Office for
Nuclear Regulation

Civil Nuclear Reactor Build - Generic Design Assessment

**Step 2 Assessment of the Reactor Chemistry of Hitachi GE's UK Advanced Boiling
Water Reactor (UK ABWR)**

Assessment Report ONR-GDA-AR-14-009
Revision 0
28 August 2014

Figure 1: Schematic of the Primary Cooling Water System

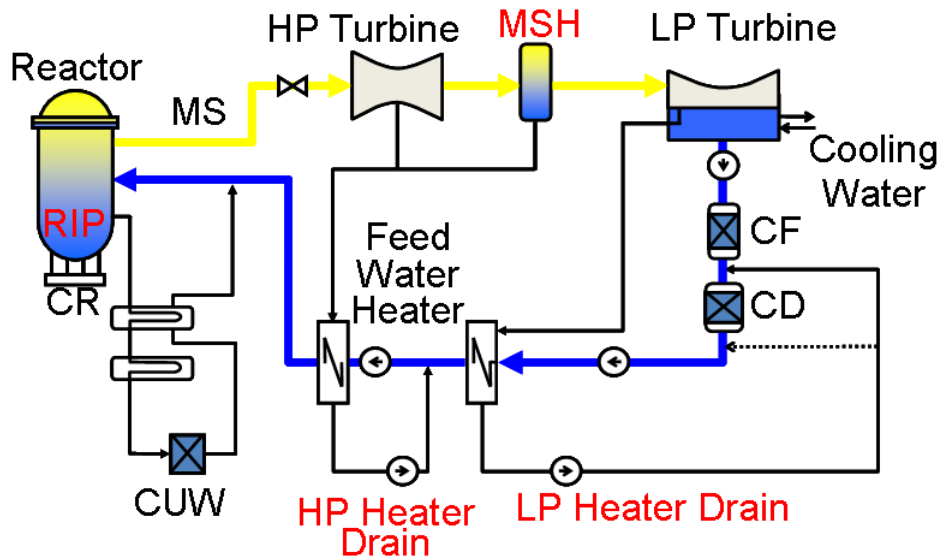
42. The coolant within the system therefore contacts many surfaces within this circuit, including the fuel, RPV, steam, feed, and other pipework which constitutes the primary and secondary containment boundaries for radioactivity generated within the plant. Due to the direct cycle nature of the plant the pressure and temperature conditions vary greatly around the system, as does the material choices for the various components. The operating chemistry for this system therefore needs to balance these conditions while meeting the safety functions. The importance of this system has meant that a large portion of my assessment in Step 2 has been focussed here.

43. Before discussing the claims made by the RP for this system, some background information on chemistry effects in the system during normal operations is described below, to give context to the assessment that follows. These effects show how some of the main hazards in this system arise, namely radioactivity, gaseous radiolysis products and conditions which could degrade fuel or structural materials.

Figure 2: Schematic of the Spent Fuel Pool

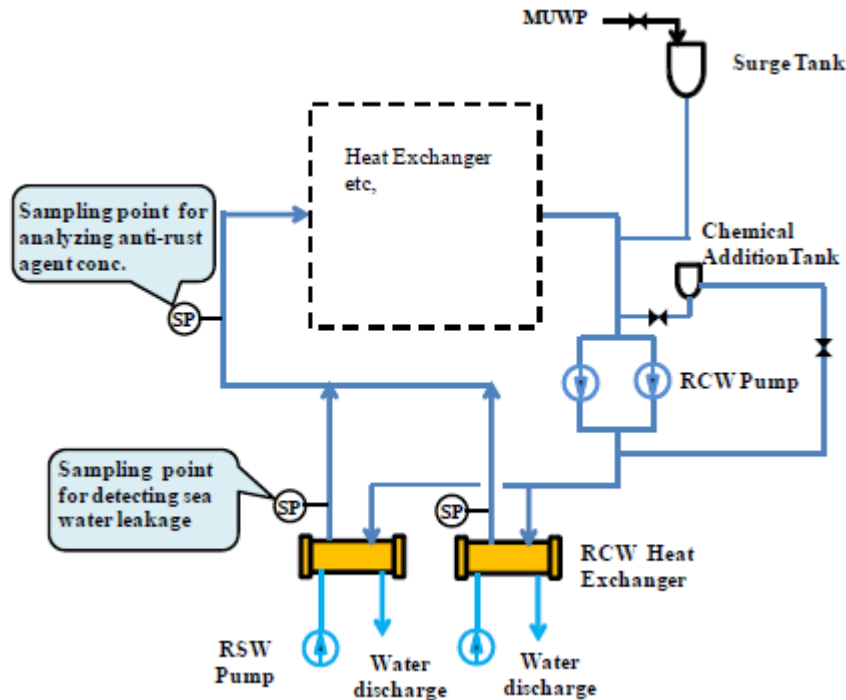
81. The claim on reduction of radioactivity ALARP in the SFP is important. I would expect this to be addressed as part of the response to RO-ABWR-0006 (Ref. 24).

84. The RP has defined a reasonable basis on which to develop the chemistry related aspect of the SFP safety case for UK ABWR. The identified claims are reasonable and I judge that the RP will be able to provide the arguments and evidence to support these claims.

Figure 4: Schematic of the Suppression Pool and related systems

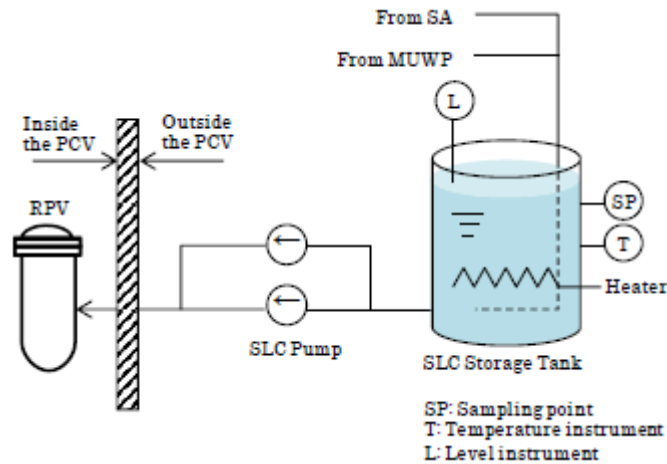
- The speciation of iodine during the accident may be important, particularly if volatile organic iodine species form that are difficult to remove;
 - The evidence which supports the claimed behaviour of iodine will need to be demonstrated to be suitable for conditions in UK ABWR (for example, under nitrogen atmospheres as opposed to air) and consistent with the current understanding of iodine behaviour;

- The justification for the claim regarding pH control in the suppression pool, in particular whether it reduces risks ALARP;
- Further development of the claims for the suppression pool, including those engineered systems which control or deliver the operating chemistry;
- Details on other uses for the suppression pool water and relevance of the suppression pool water chemistry for these.
- The sampling and analysis arrangements which are part of the design;
- Identification and development of chemistry related limits and conditions.
